05 Landscape Concept: Amendment Response

Landscape Concept: Amendment Response

Fig 8: Extract of Section 5.8 of the originally submitted Design and Access Statement - Concept Ideas

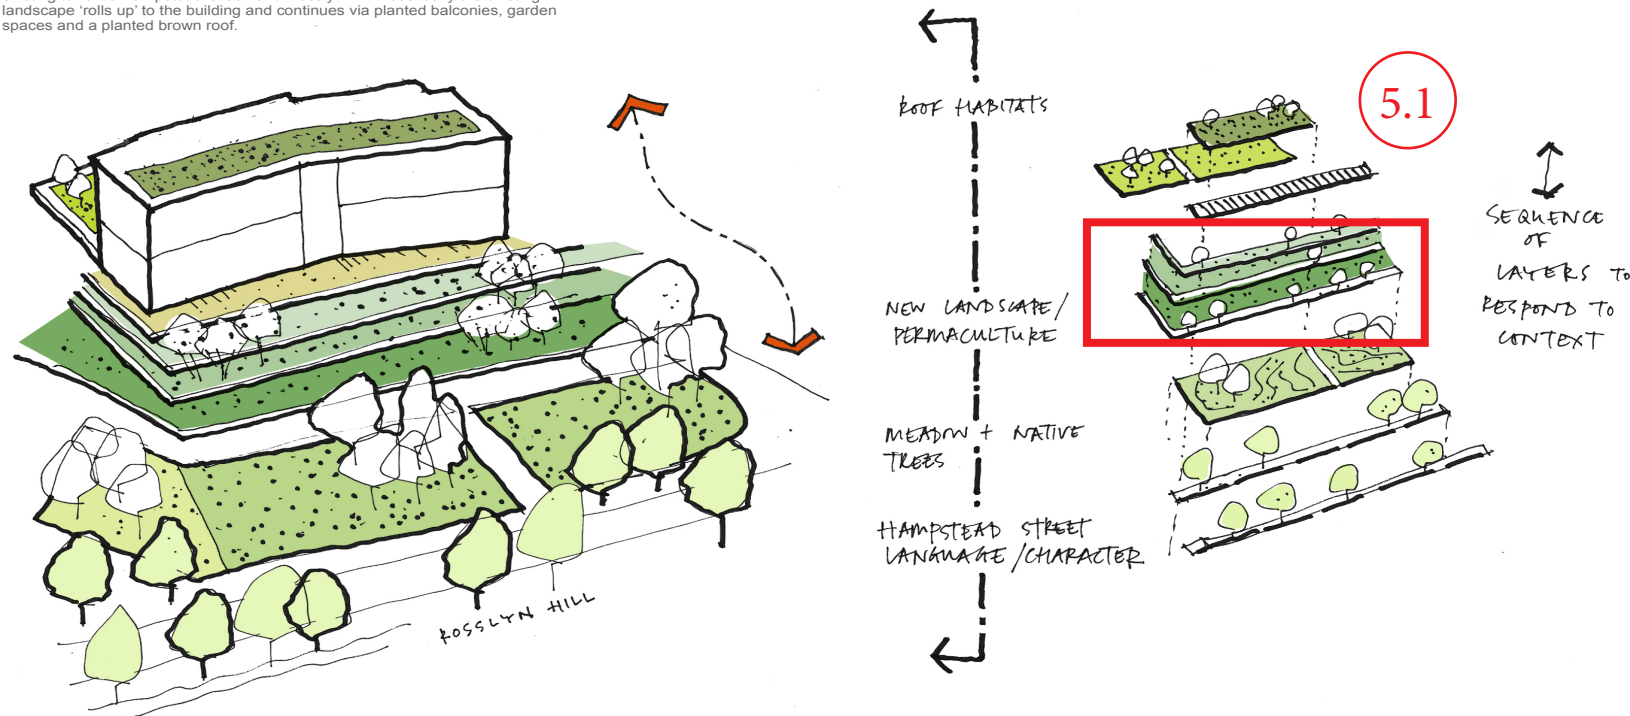
The only change from the consented scheme proposal for the external terraces is the proposed reduction in the terraces’ width, in order to accommodate the existing footprint of the public footpath as closely as possible.
